SOURCE: JAPAN

TITLE : COMMENTS ON RECOMMENDATIONS H.221 AND H.200/AV242

Title : Proposed improvements to H.221

TITLE : COMMENTS ON RECOMMENDATION H.221

Fig.1 Negotiation Sequence Sample 1

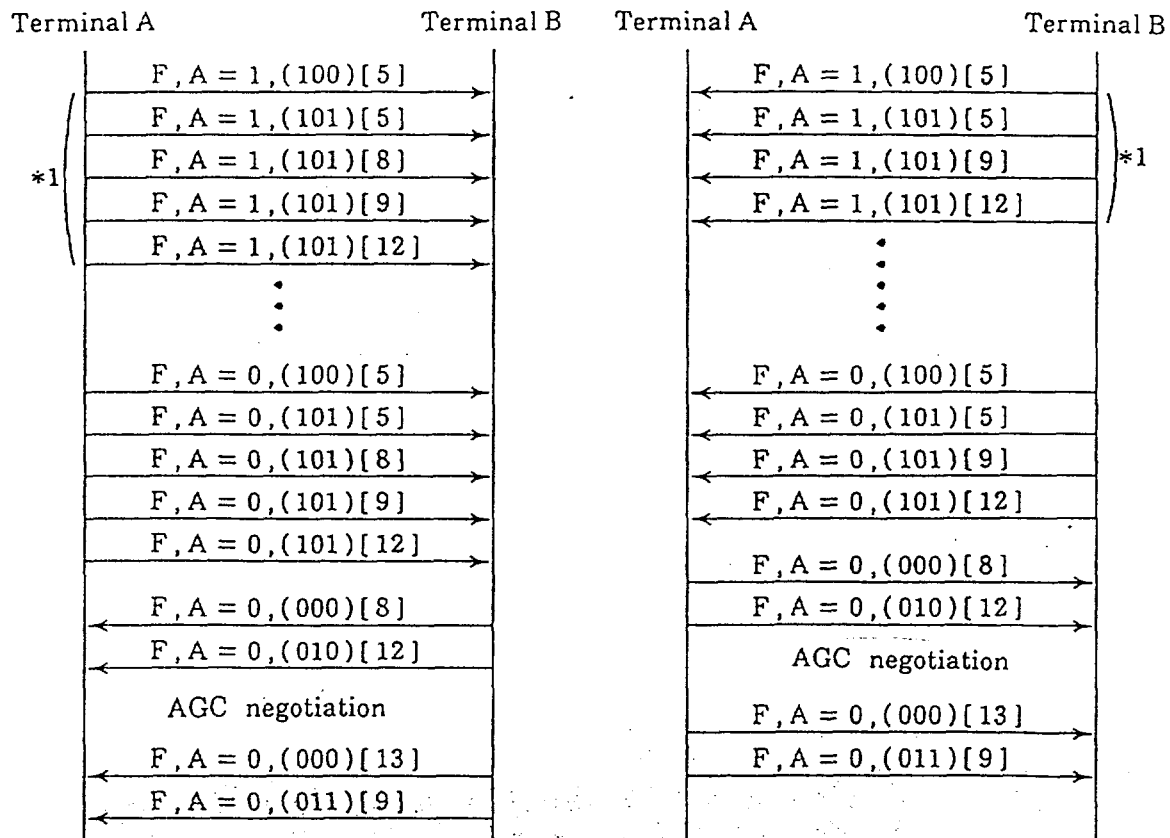
Annex 2 illustrates some examples of negotiation sequence between the same/different type of terminals based on the proposed BAS Codes. Note that AC Command sequence (F,A=0, (010) (12) and (13)) may be deleted as a result of further study mentioned in ii) above.

Attachment 1 Transmission decoder structure conforming to H.221

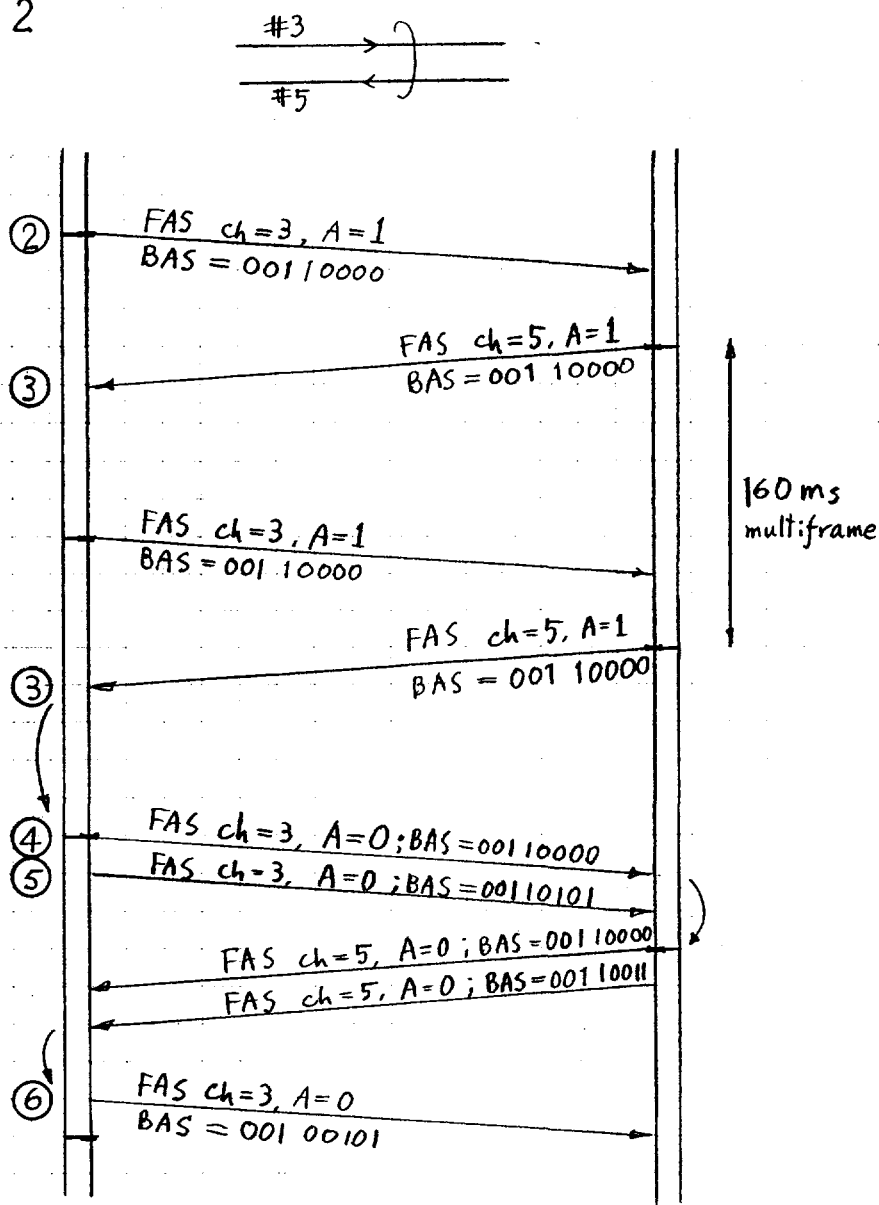
We understand that the basic role of Rec. H.221 is in providing a demultiplexing rule for the following logical channels with their respective decoder or protocol handler; FAS, BAS, Audio, Video, Data and Application Channel as in Attachment 1.

Hence, physical bit positions should be reworded as eg. Application Channel Position (ACP) to avoid confusion. ACP is obviously used for transmitting not only Application Channel codewords, but also video and data.
